Neil Baker
Mill Street Market
4086 Broadway
Grove City, Ohio 43123

Please see my responses to your request for additional information.

Diagram 2

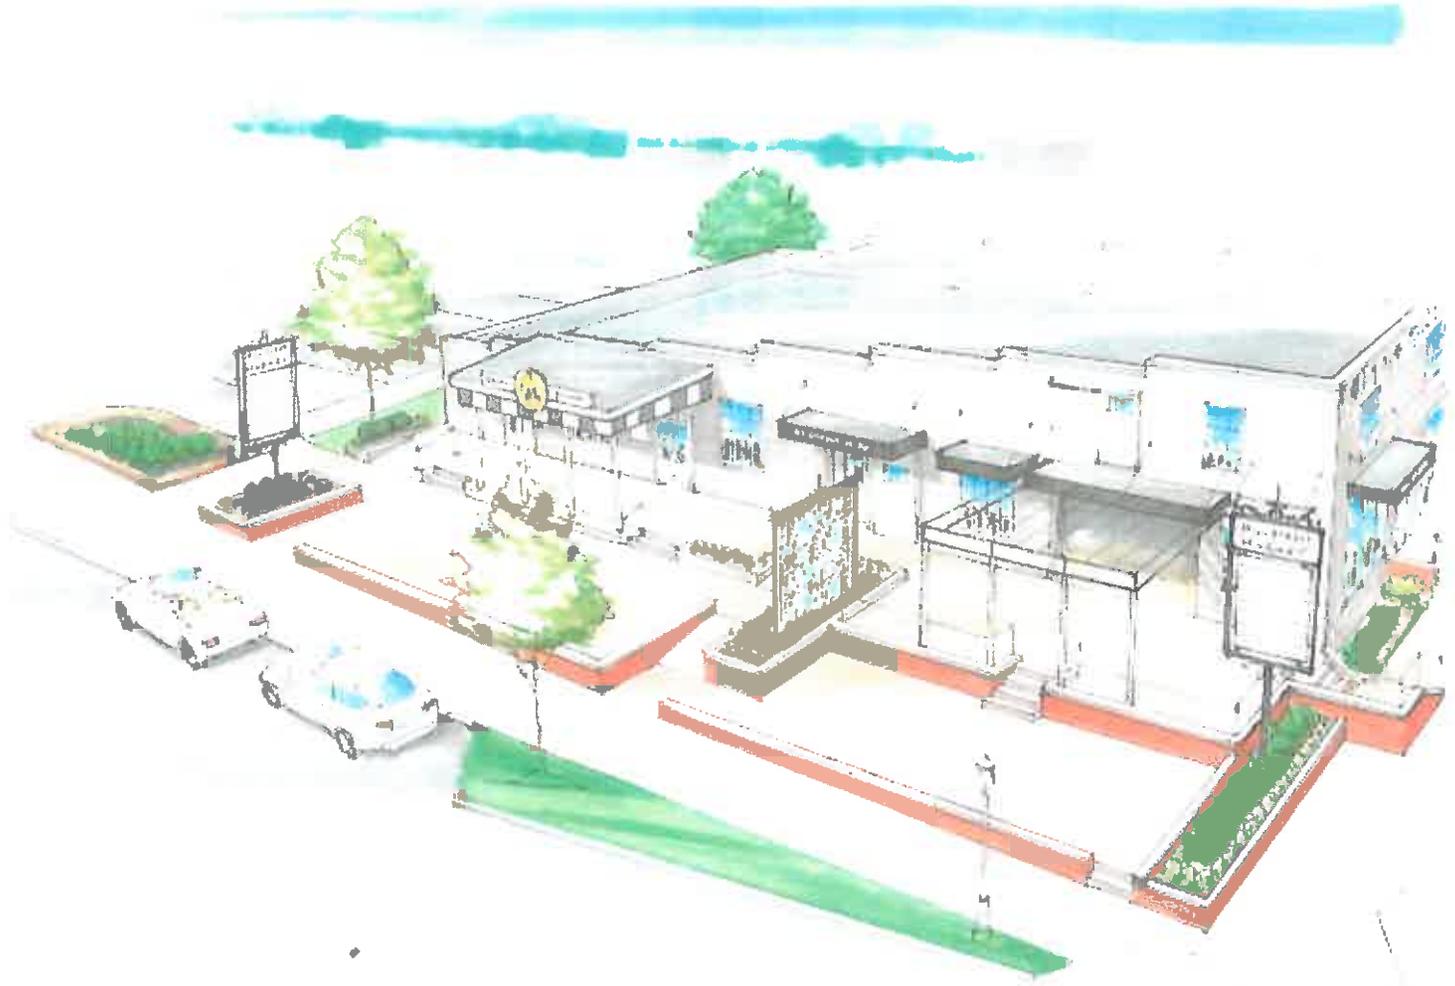
The improvements include a brick retaining wall surrounding the patio with breaks to allow for steps for ingress and egress points. The brick will be of the same texture and color of the existing Mill Street exterior brick which is a close match to the City of Grove City Town Center brick (see diagram 2).

- 2) See Diagram 1.
- 3) See Diagram 2.
- 4) To be submitted at a later date.
- 5) To be submitted at a later date.
- 6) To be submitted at a later date.
- 7) To be submitted at a later date.
- 8) Noted an Diagram 1
